ZONING CHANGE REVIEW SHEET

CASE: C814-2018-0121 -- 218 South Lamar

ADDRESS: 218 South Lamar Boulevard Southbound

4-Lane Divided, 60' Curb-to-Curb
Back-of-Curb Condition F
Barton Springs Road to Riverside Drive

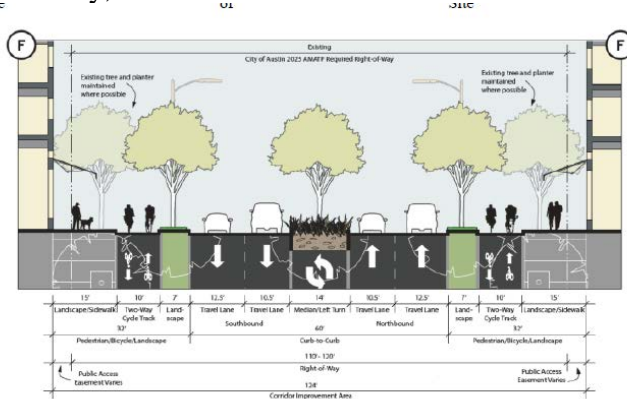
TR2. Include the below streetscape in the land use plan. Contact this reviewer for a more legible copy of it if necessary. This project is adjacent to a street that has been identified in Austin's Corridor Mobility Program (S Lamar). The sidewalk and bicycle facilities shall comply with the required cross-section at the time of the site plan application. The cross section that will be required is shown below. Find additional information about the Corridor Mobility Program here: <https://data.austintexas.gov/stories/s/Corridor-Mobility-Program/gukj-e8fh/>. Any proposed curb relocations on S Lamar requires coordination with the Corridor Planning Office and Bicycle Program. The cross section will include a 7' planting zone with street trees, a 10' two-way cycle track, and a 15' clear zone all behind curb. Additionally, a protected intersection will be required at Toomey, to be reviewed at the time of Site Plan.

CONCEPTUAL DESIGN - 7TH FLOOR

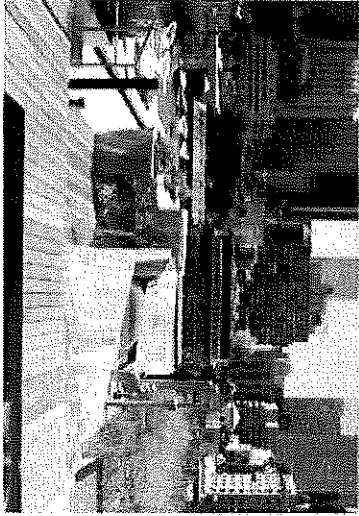
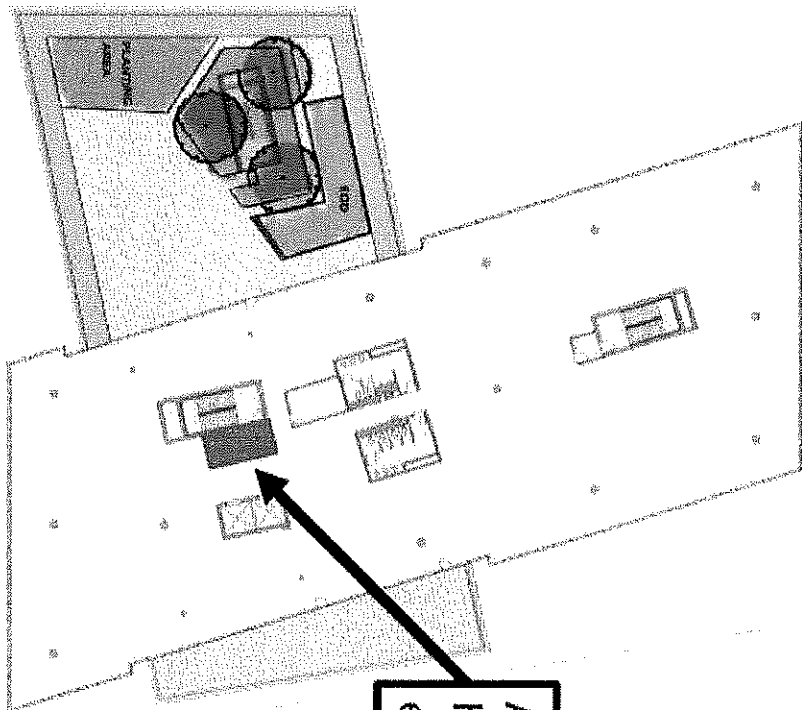
U0: Attached drawings do not show elevator over run. Please provide.

U1: Comment cleared.
